Access Compliance Report

Public Rights-of-Way

(Curb Ramps)

Intersection ID: N/A	Main Street: ELGIN_MOOR_RD	Cross Street: LANGWELL_LN	Location: NE
ADA ID: 840C12AE2D53	Ramp Type: Perp	Initial Pass/Fail: Fail	Overall Compliance: No
Codes/Mitigation Info/Possible Solution		Field Measurements/Component Compliance

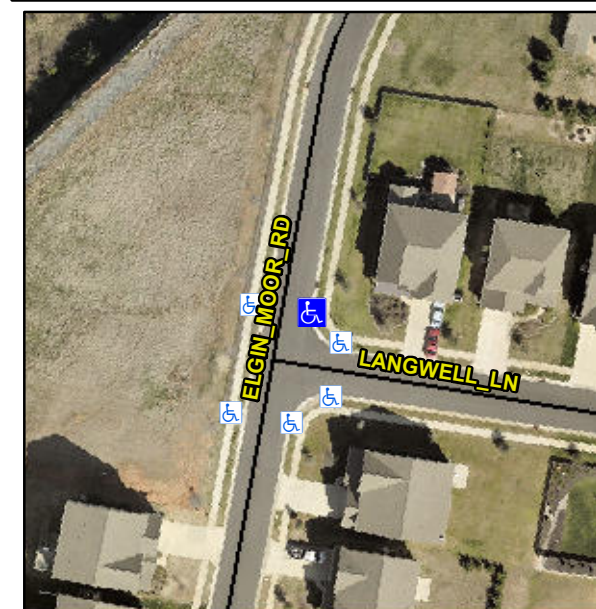
Not Found, R304.2.2, R304.5.3

Compliance	Description	Data	Compliance	Description	Data
N/A	Ramp Length (in)	47.0	No	Ramp Slope (%)	8.6
Yes	Ramp Width (in)	48.0	No	Ramp XSlope (%)	4.9
N/A	Flare Type LT	N/A	N/A	Flare Type RT	N/A
N/A	Flare Slope LT (%)	N/A	N/A	Flare Slope RT (%)	N/A
N/A	Flare Traversable LT?	N/A	N/A	Flare Traversable RT?	N/A
N/A	Landing Length (in)	N/A	N/A	DWS Provided?	N/A
N/A	Landing Width (in)	N/A	N/A	DWS Contrast?	N/A
N/A	Landing Slope (%)	N/A	N/A	DWS Length (in)	N/A
N/A	Landing X Slope (%)	N/A	N/A	DWS Full Width?	N/A
N/A	Landing Curb? (Y/N)	N/A	N/A	DWS Offset (in)	N/A
N/A	Shared Landing?	N/A			
N/A	Gutter Ponding?	N/A	N/A	Gutter Slope (%)	N/A
N/A	Gutter Lip Ht (in)	N/A	N/A	Gutter X Slope (%)	N/A
N/A	Painted X Walk1?	No	N/A	Painted X Walk2?	N/A
	X Walk 1 Direction	To NW		X Walk 2 Direction	N/A
N/A	X Walk 1 Width (in)	N/A	N/A	X Walk 2 Width (in)	N/A
	X Walk 1 Slope (%)	1.4		X Walk 2 Slope (%)	N/A
	X Walk 1 X Slope (%)	3.6		X Walk 2 X Slope (%)	N/A

Remove & Replace Entire Ramp.
